CITY PLANNING COMMISSION AGENDA

ITEM NOS: 4.A- 4.C

PROJECT: PENROSE-ST. FRANCIS NEW CAMPUS

Subject: Penrose-St. Francis New Campus – Concept Plan
City of Colorado Springs, El Paso County, CO; CGS Unique No. EP-16-0002

FIGURE 2

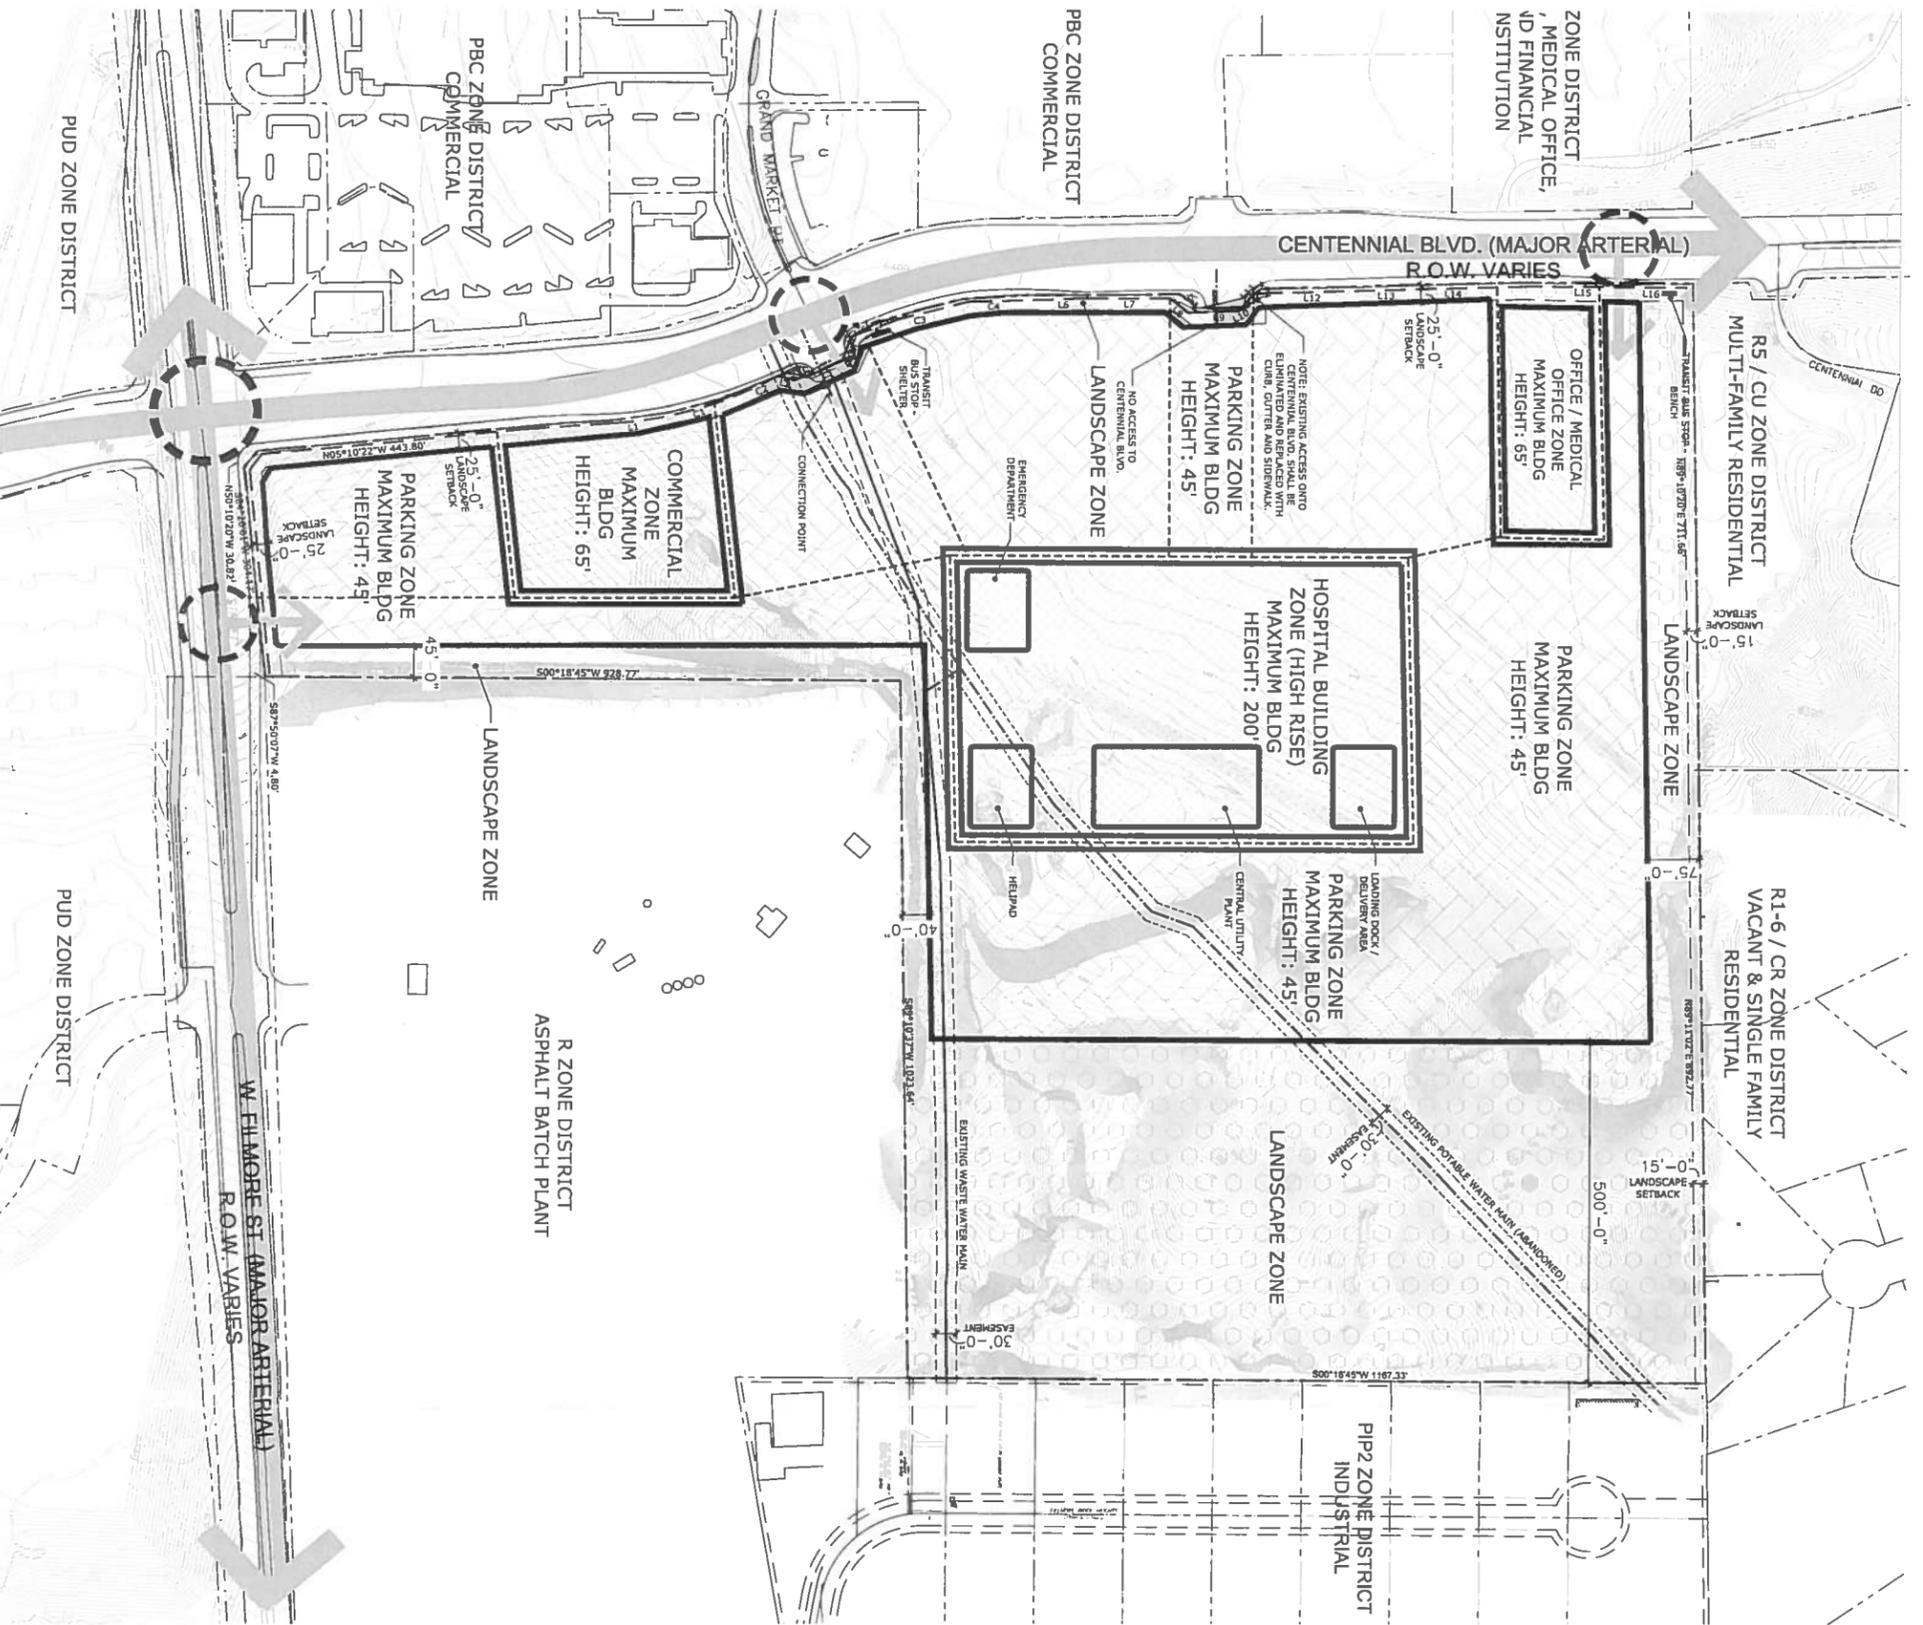
Technical and Informational Modifications to the Concept Plan:

1. Include a note on the concept plan that states "A geologic hazard report will be required with the submittal of a development plan for the hospital building zone and the parking zones north and east of the hospital building zone."
2. To the west of the property identify the land uses as office, medical office, vacant and financial institution. The note has been added, but is not entirely readable. Ensure the note is legible.
3. Scale the site plan to a typical scale, for example 1"-100'.
